Addendum #: Addendum #4
Issue Date: 04/08/2024

The following additions, clarifications and revisions have been made to the Contract Documents:

Job #: 8-22-01-011 Edgar County Jail
 TBD SPRINGFIELD RD
 PARIS, Illinois 61944

Drawn by: *Adler*
Copyright © 2024 by HMN Architects, Inc.
PLUMBING WATER & GAS
FIRST FLOOR PLAN -
OVERALL

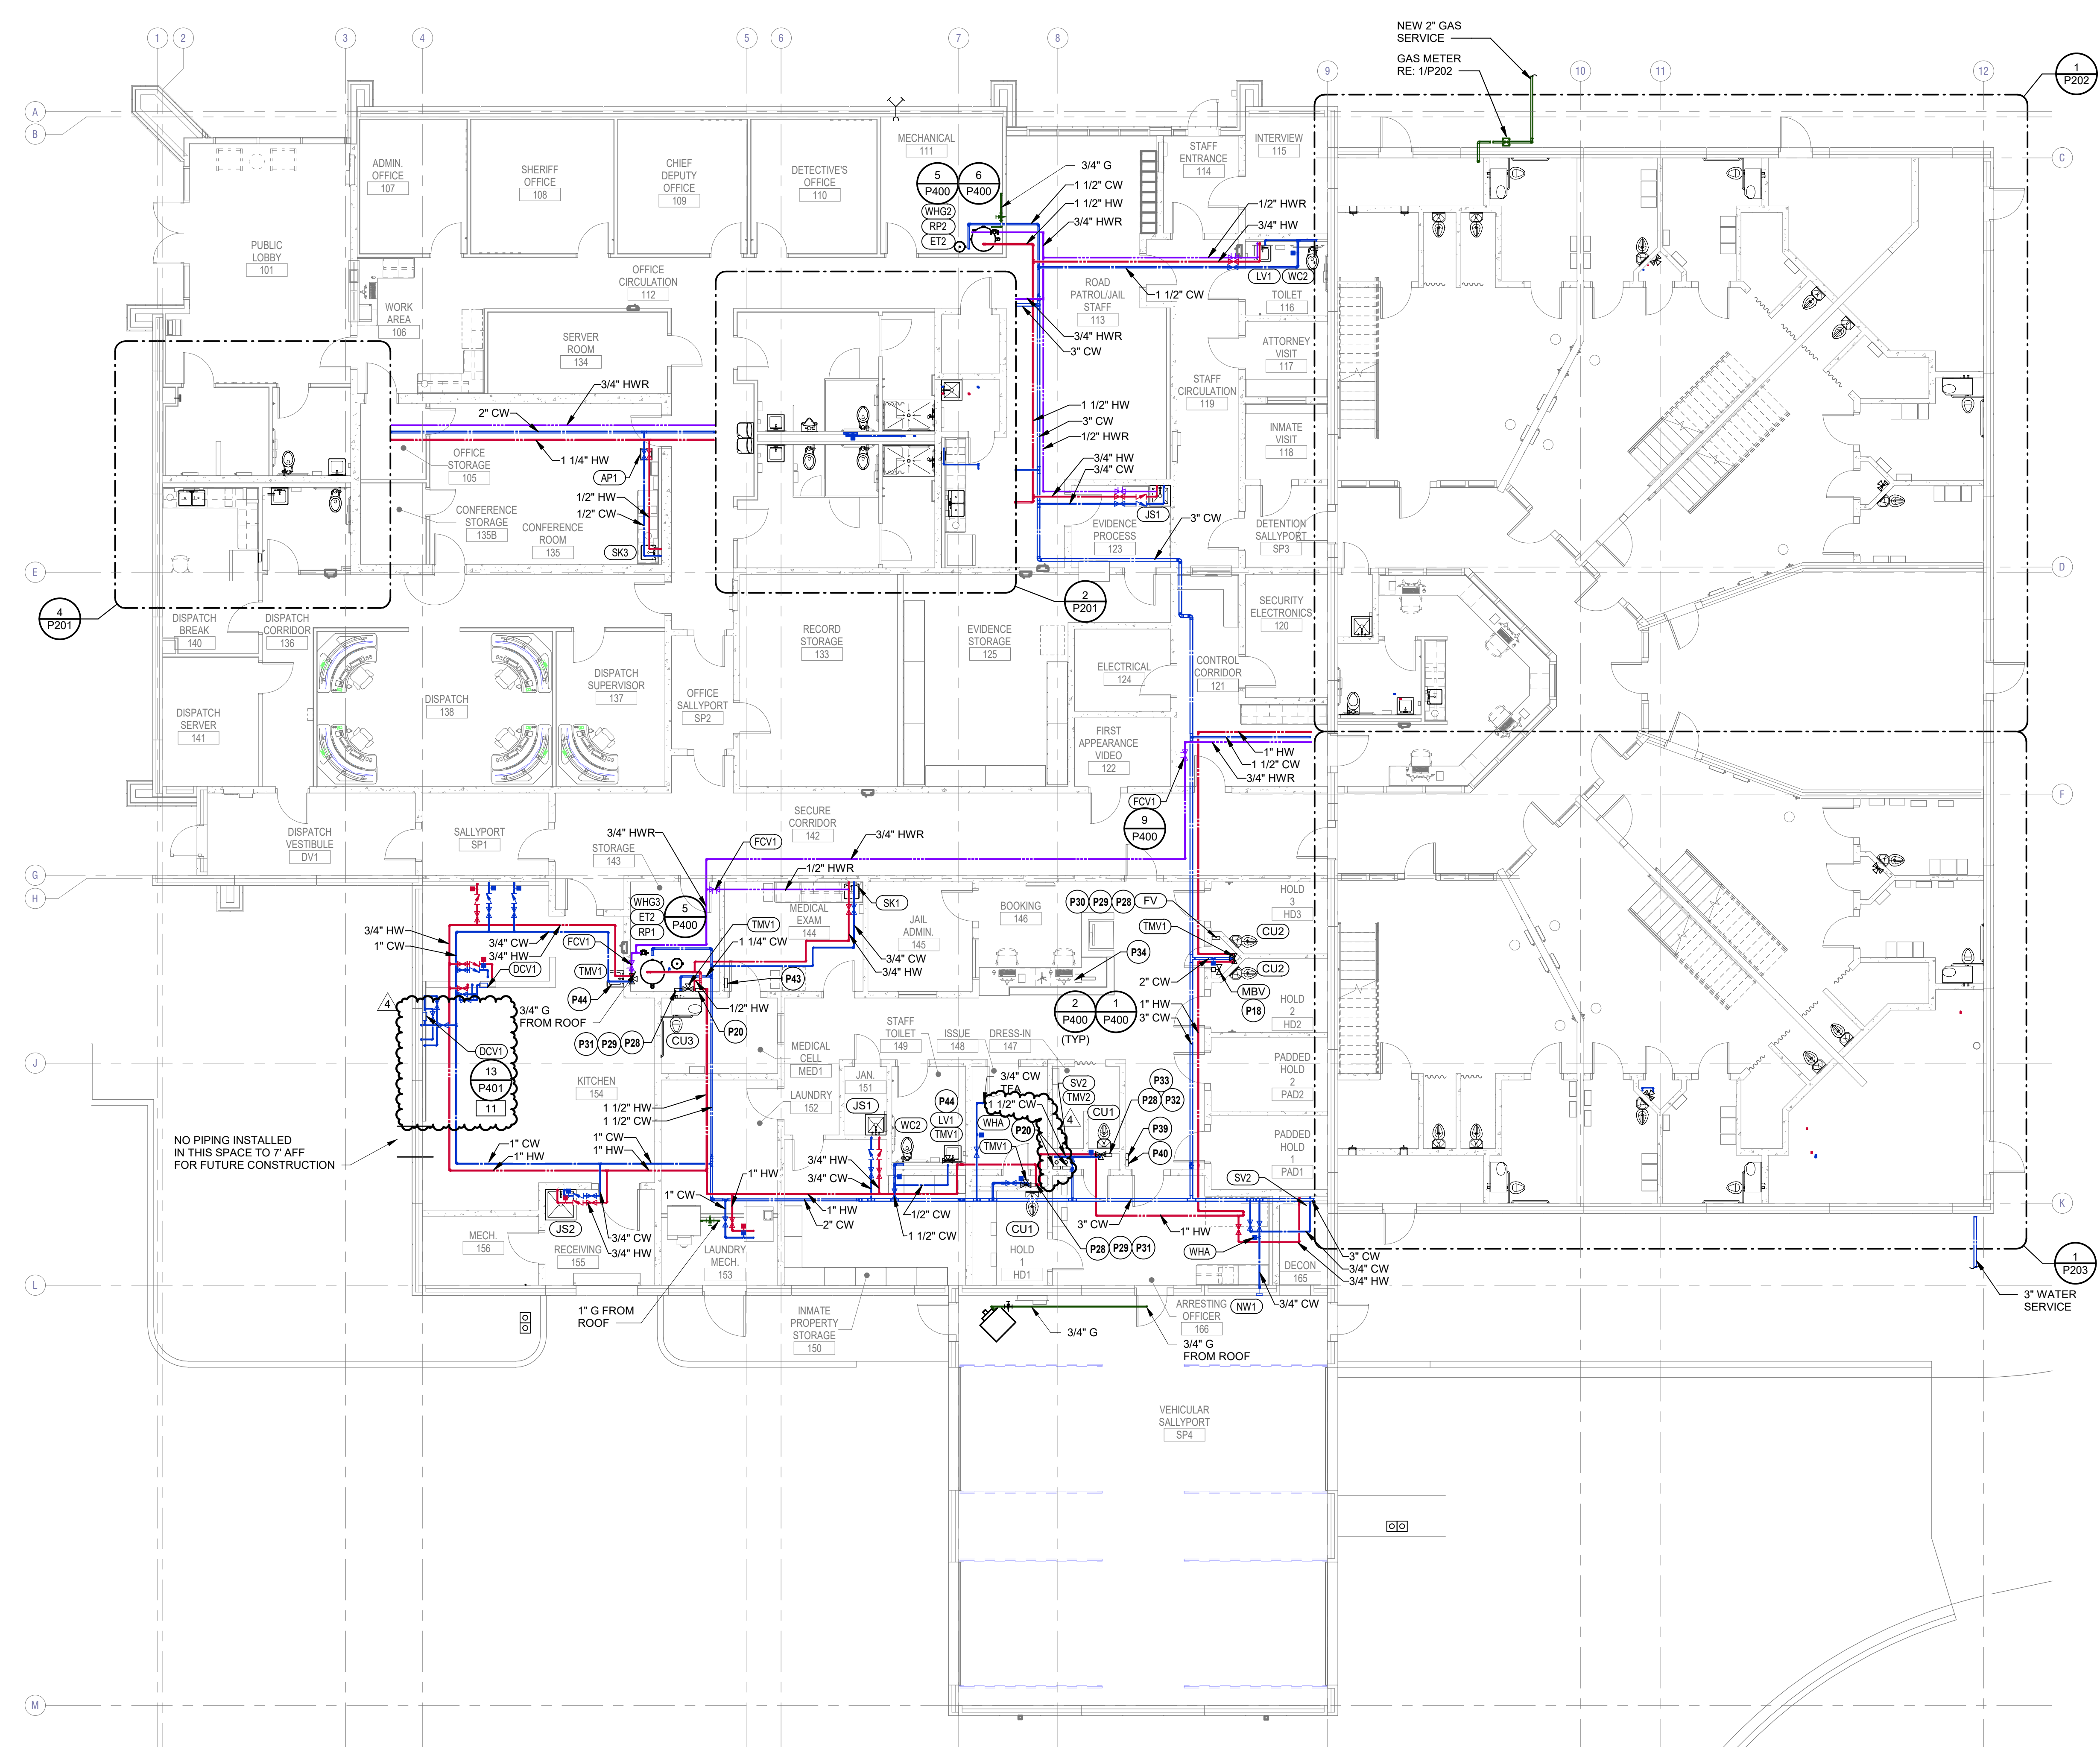
- A. Revised kitchen piping.
 - B. Revised notes for condensate drain discharge.
 - C. Relocated floor drain serving Decon 165
3. SHEET P103 – PLUMBING WATER & GAS FIRST FLOOR PLAN - OVERALL

- A. Revised kitchen equipment connections.
 - B. Revised pipe and notes to FFD flush valve location.
4. SHEET P104 – PLUMBING WATER & GAS MEZZANINE PLAN - JAIL

ENTIRE SHEET HAS BEEN UPDATED.

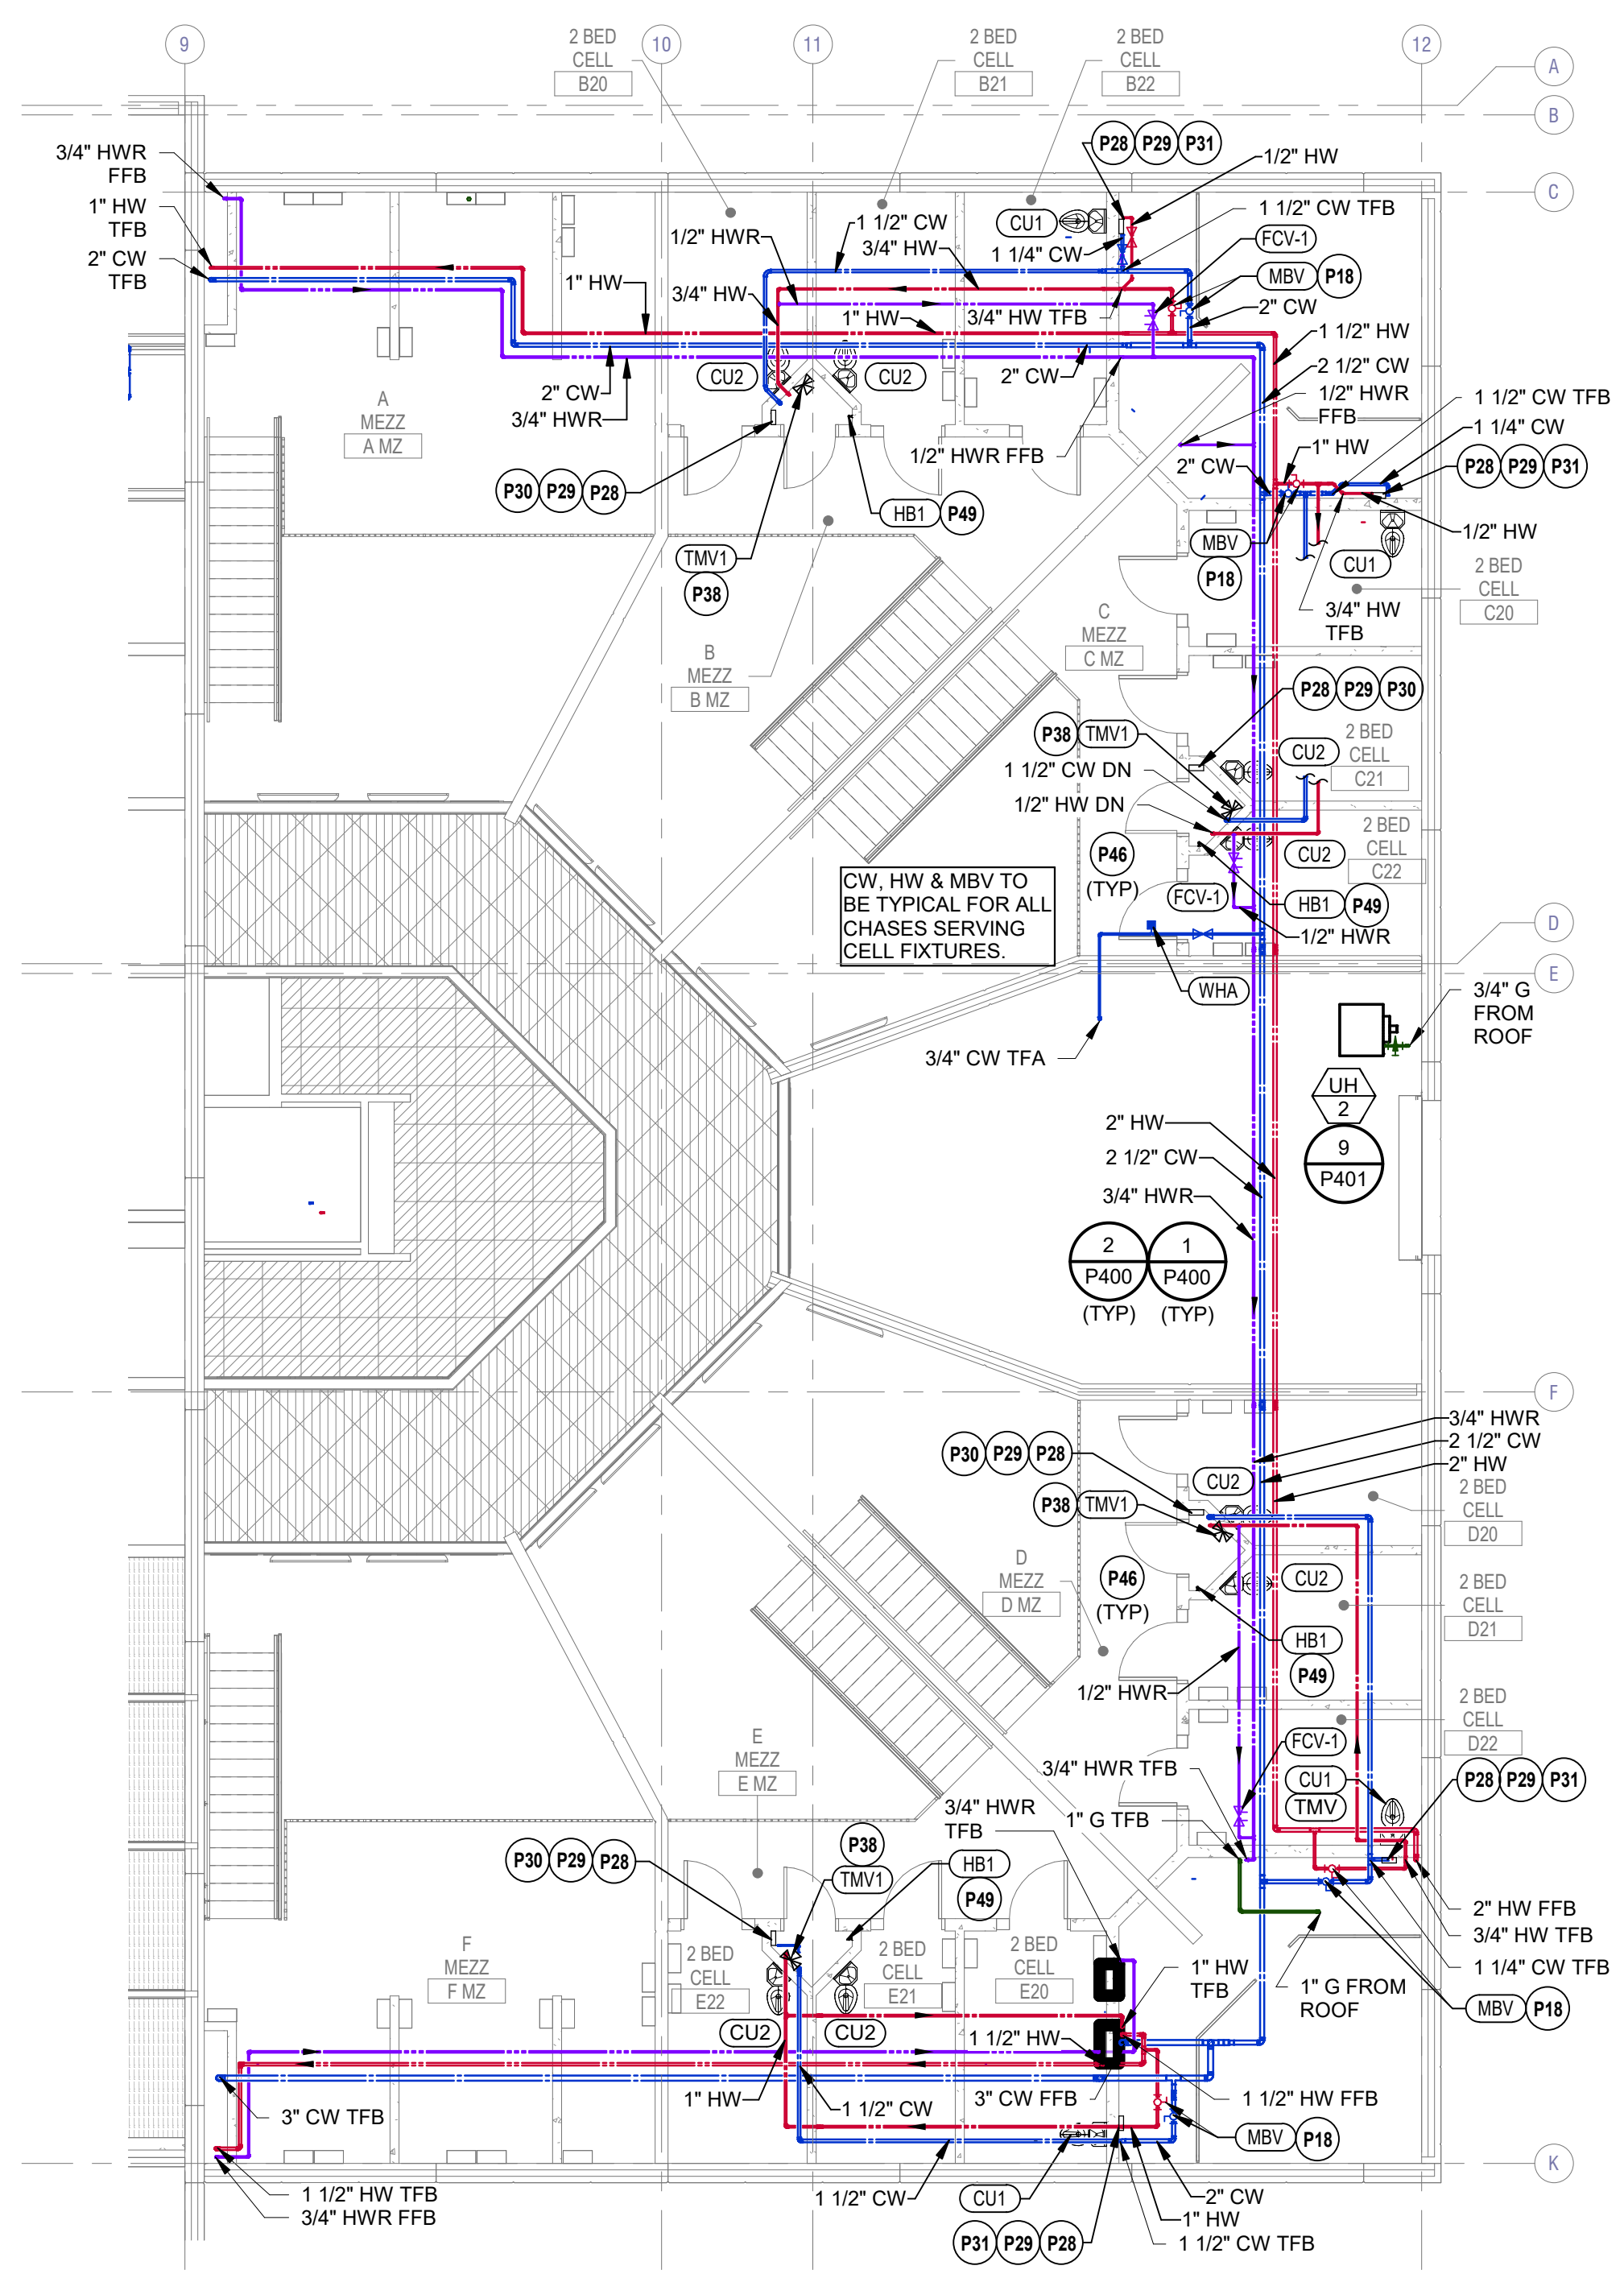
- A. Added hose bibbs to chases and remove recessed hose bibbs.
 - B. Revised pipes serving Pods A, B & C.
5. SHEET P202 – PLUMBING PLAN – ENLARGED – JAILS NORTH

- A. Revised entire sheet.
6. SHEET P203 – PLUMBING PLAN – ENLARGED – JAILS SOUTH
 - A. Revised shower piping.

PLUMBING PLAN -
ENLARGED - JAIL SOUTH

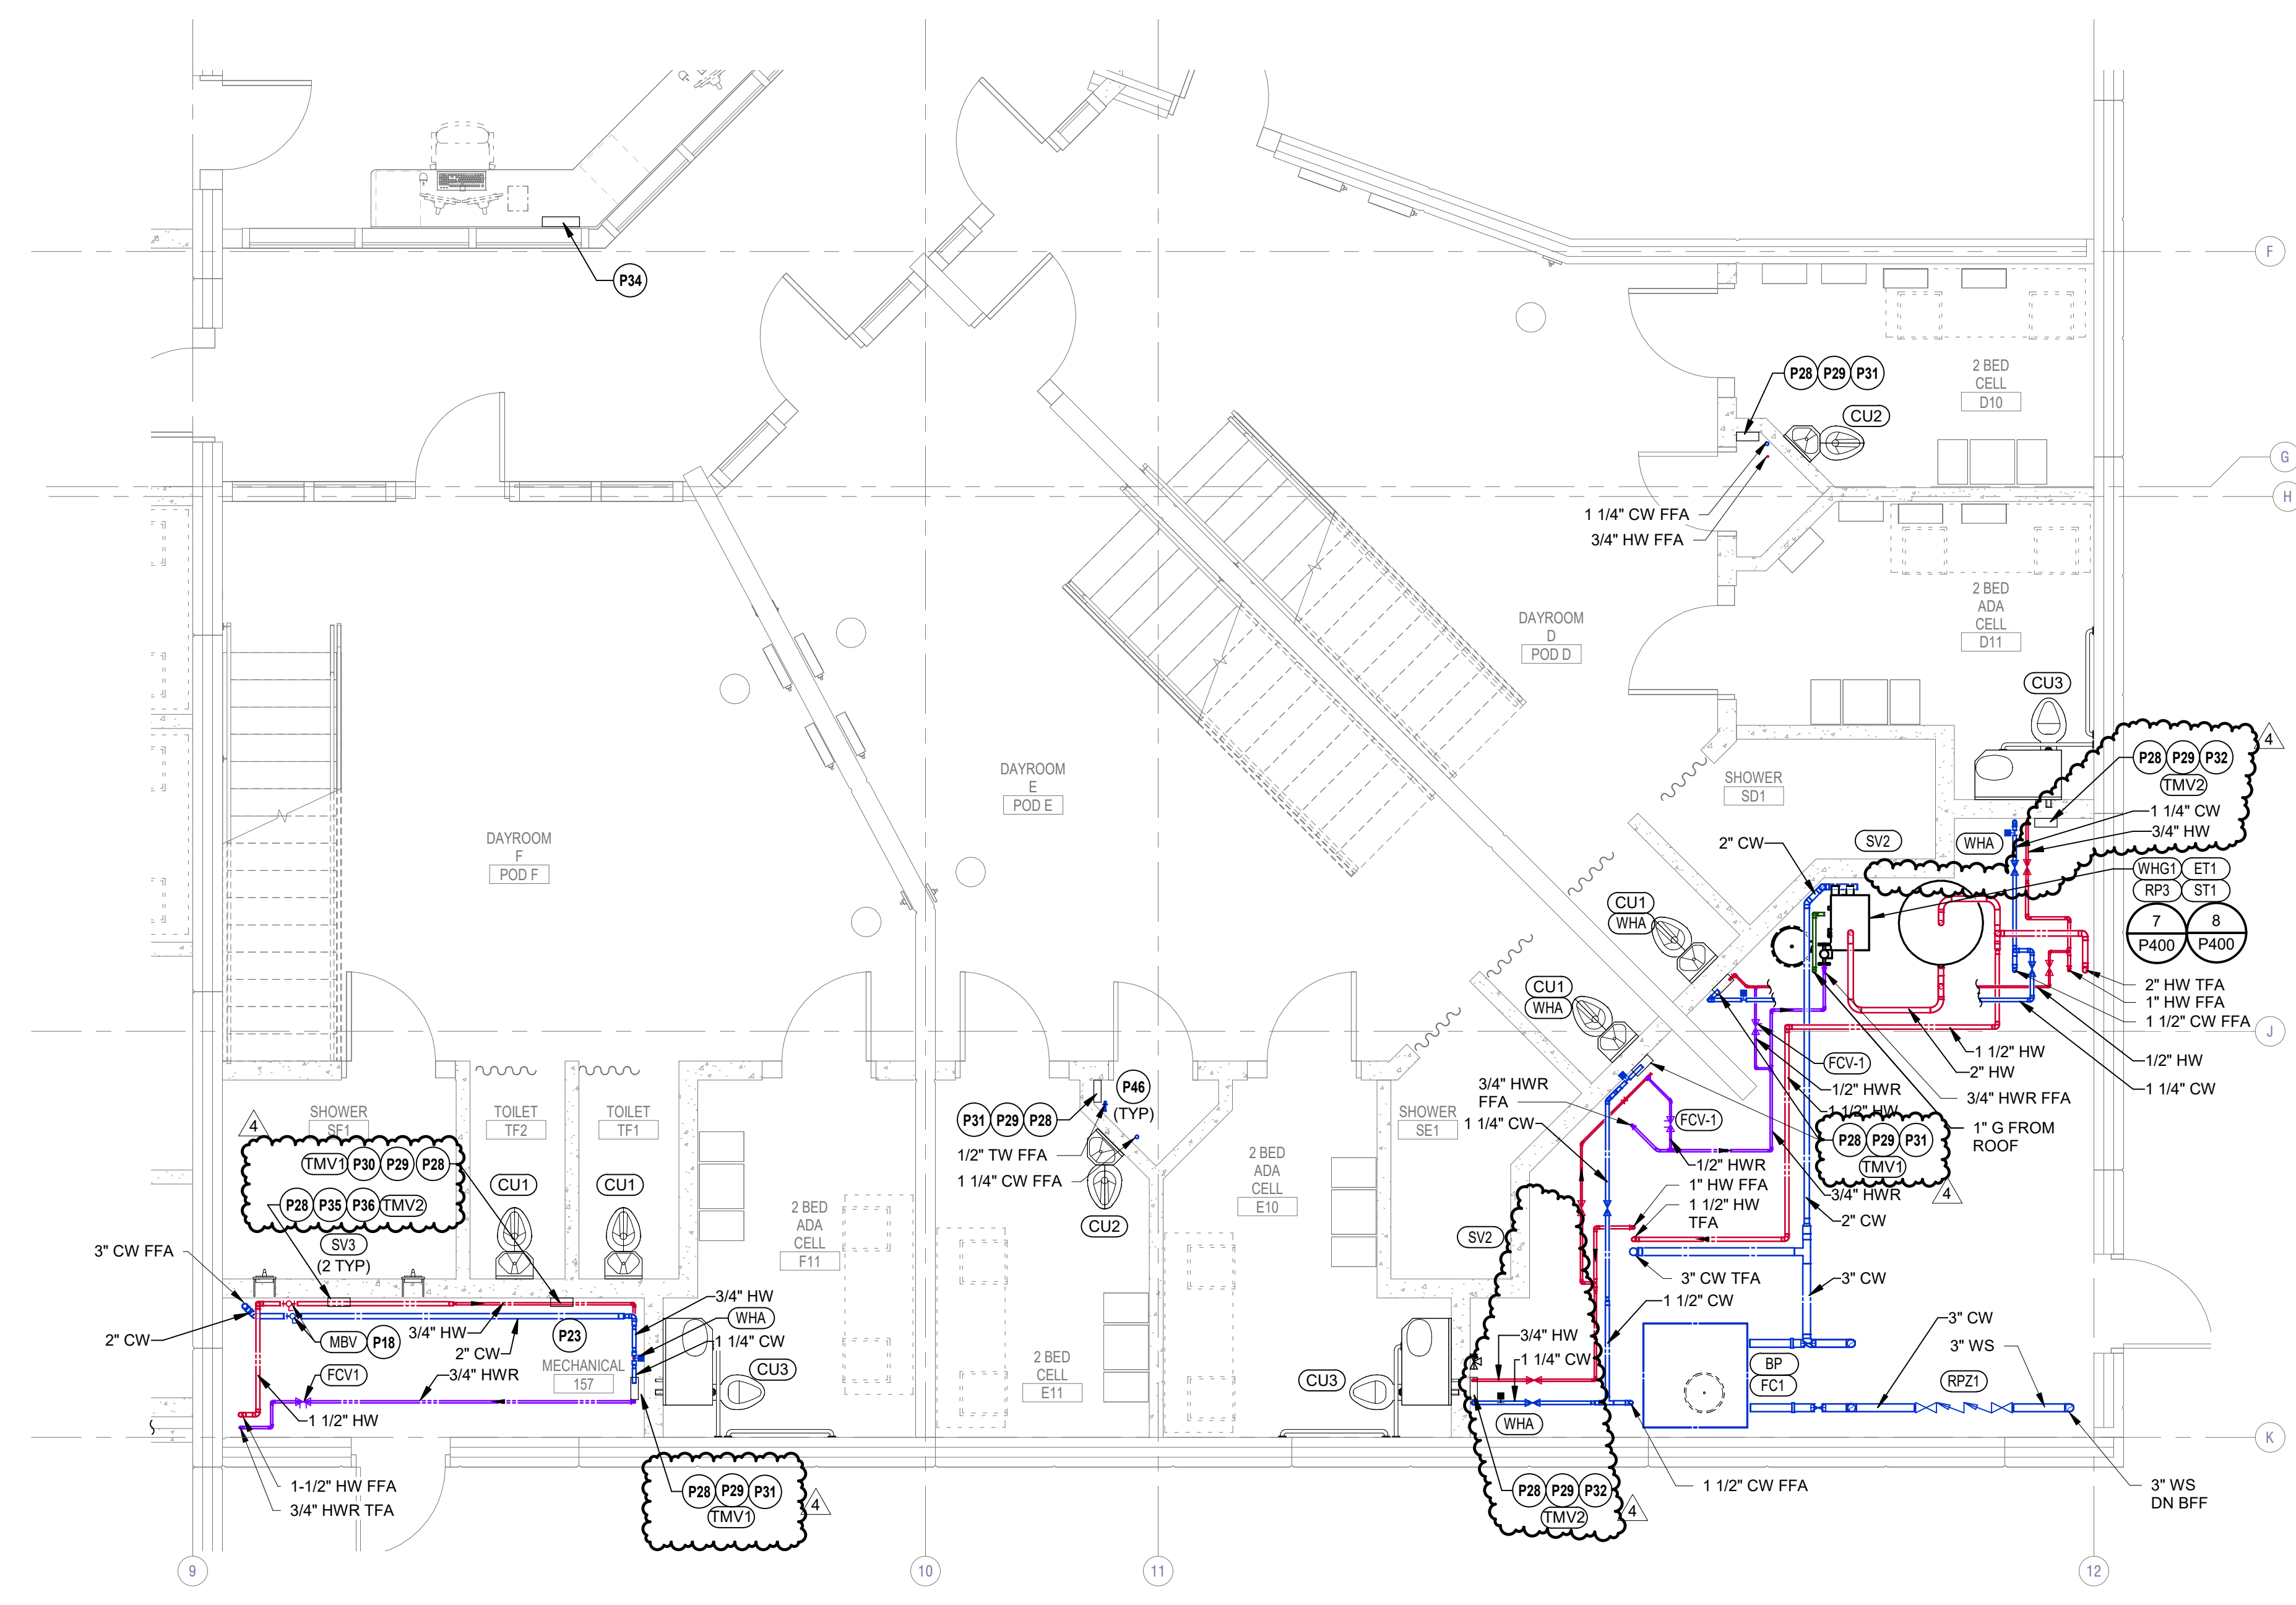
- B. Added TMV callouts.
- 7. SHEET P300 – PLUMBING RISER DIAGRAM
 - A. Revised riser per plan updates.
- 8. SHEET P301 – PLUMBING RISER DIAGRAM
 - A. Revised riser per plan updates.
- 9. SHEET P401 – PLUMBING DETAILS
 - A. Added Detail #13.
- 10. SHEET P500 – PLUMBING SCHEDULES
 - A. Revised SG.
 - B. Added HB1.
